**EDUCATION BUILDING II**

UCR PROJECT NO.: 954045 / CAAN NO.: P5836

**DESIGN PACKAGE 4**

PARTIAL FLOOR PLAN - LEVEL 1 EAST

SHEET TITLE A2.21A

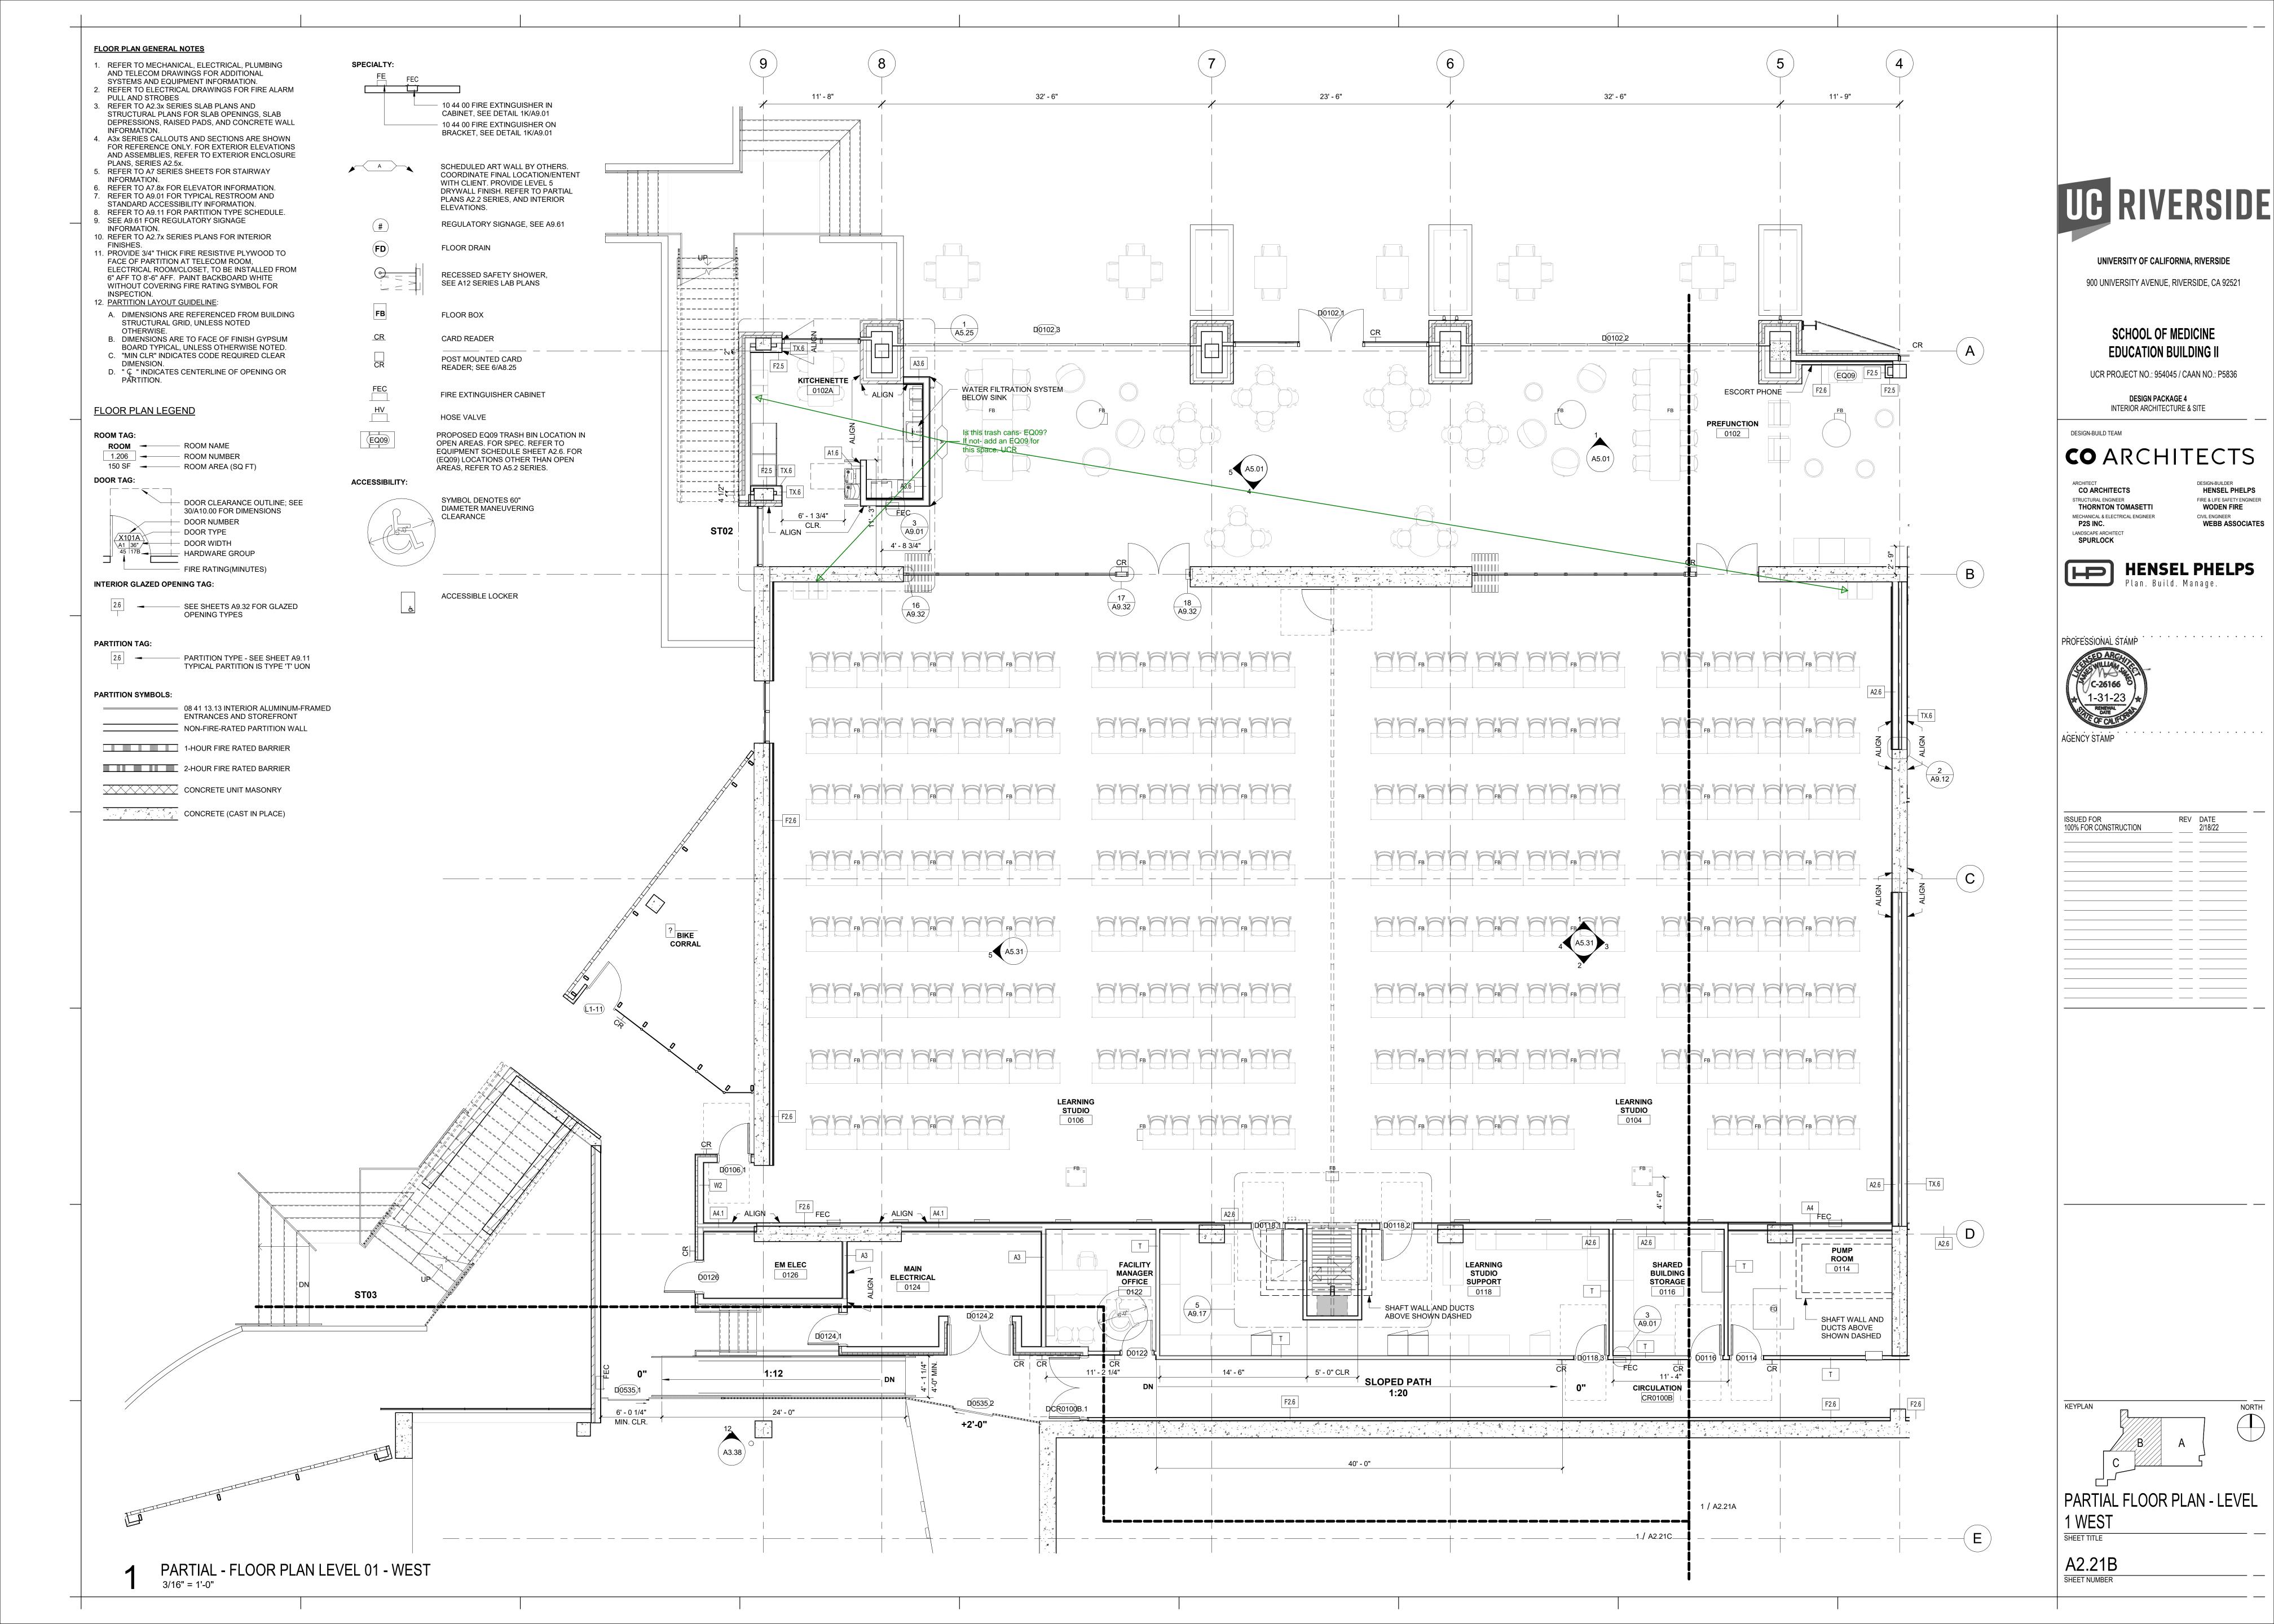
Repeated comment: Identify locations of AEDs, emergency phones, etc. Typical all floors. DB team to propose locations and UCR will review and approve with stakeholders. UCR

On which plan is 2 way communication devices (identified to be on elevator lobbies) indicated?

> Please include corner guards. They were taken out of the package- and are required by Campus

Std. UCR

epeat comment: Identify h the plan and mark

legend where chair rails re. If located elsewhere

let us know the sheet

thair rails are required per the BOD for the rotection of the walls in

all specified rooms. UCR.
